Relatório Integrado de Revisão CAD

Original: 13358002_REV_7_draw_1.pdf

Revisado: 13358002_REV_8_draw_2.pdf

Drawing No.	13358002
Title	GASKET - VALVE PLATE
Compressor Series Code	-
CR	26177
Classification	GASKET - VALVE PLATE
Last revision date	2026.06.05

Comparison - page 1

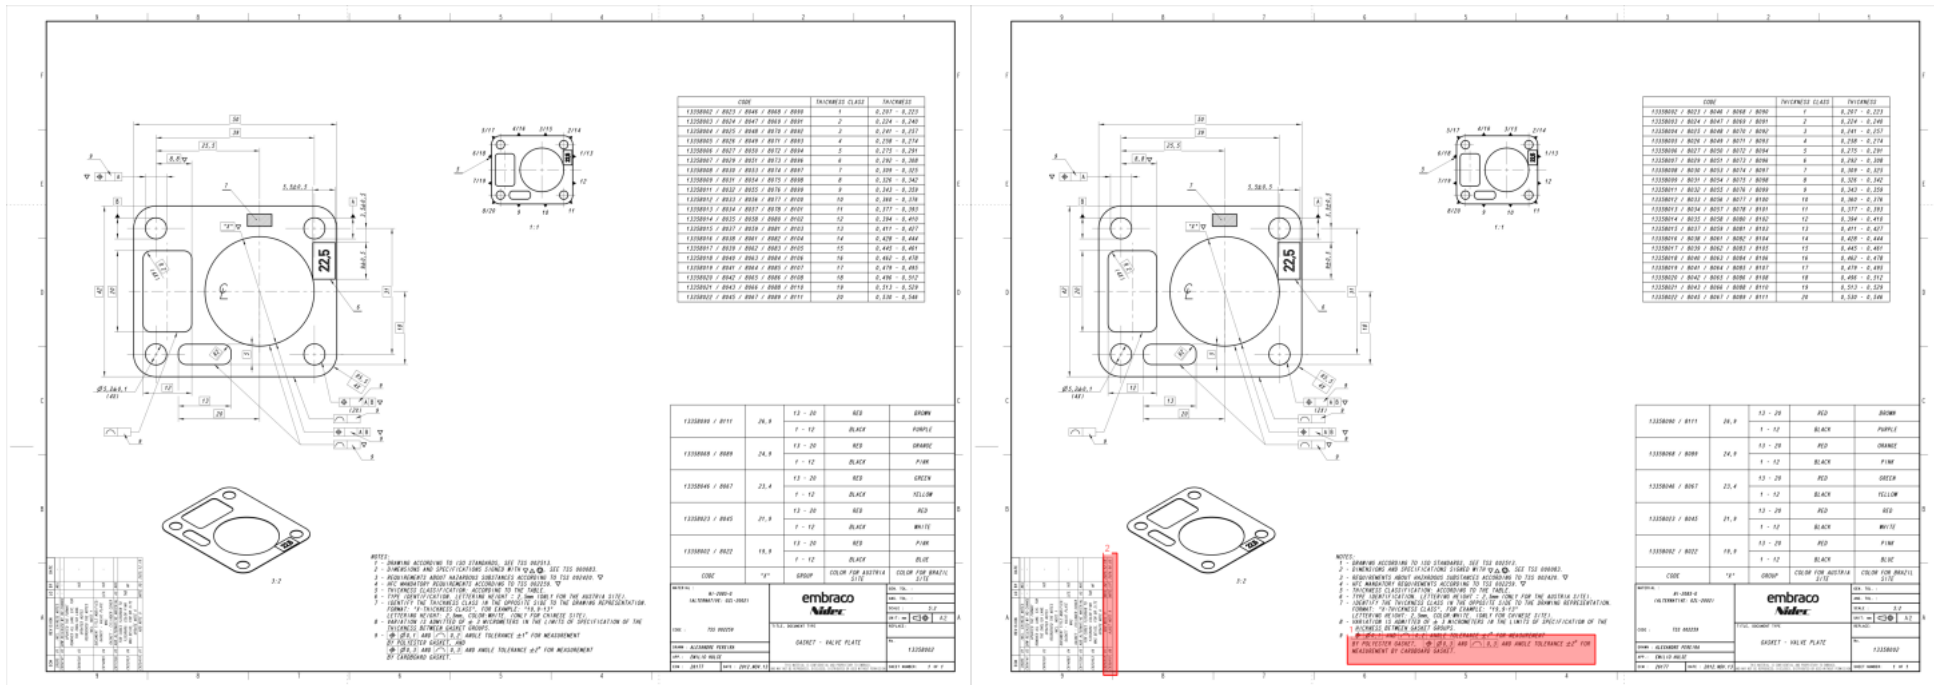
ID	Difference found	Recommended Action
1	The phrase "BY CARDBOARD GASKET." was moved to a new line and the text was adjusted to include "MEASUREMENT BY CARDBOARD GASKET.". The position of the geometric tolerance symbols for cardboard gasket was also shifted left.	Validate the change against the applicable technical requirement.
2	A new revision entry was added to the revision block. The new entry is labeled '08', with revision number 'CR30970', description 'ADJUST NOTE 9', date '2026.05.05', and 'LLF' for the note ID.	Validate the change against the applicable technical requirement.

Change #1

⌀0,1 AND 110,2 ANGLE TOLERANCE ±1 FOR MEASUREMENT
BY POLYESTER GASKET, AND
⌀0,3 AND R0,3 AND ANGLE TOLERANCE ±2° FOR MEASUREMENT
BY CARDBOARD GASKET.

⌀0,1 AND 110,2 ANGLE TOLERANCE ±1 FOR MEASUREMENT
BY POLYESTER GASKET, ⌀0,3 AND R0,3 AND ANGLE TOLERANCE ±2° FOR
MEASUREMENT BY CARDBOARD GASKET.

Description: The phrase "BY CARDBOARD GASKET." was moved to a new line and the text was adjusted to include "MEASUREMENT BY CARDBOARD GASKET.". The position of the geometric tolerance symbols for cardboard gasket was also shifted left.

Change #2

CR25474	07	ADD NOTE 9	NOTE ID	2025.12.18
---------	----	------------	---------	------------

CR25474	07	ADD NOTE 9	NOTE ID	2025.12.18
CR30970	08	ADJUST NOTE 9	NOTE LTF	2026.06.05

Description: A new revision entry was added to the revision block. The new entry is labeled '08', with revision number 'CR30970', description 'ADJUST NOTE 9', date '2026.05.05', and 'LLF' for the note ID.
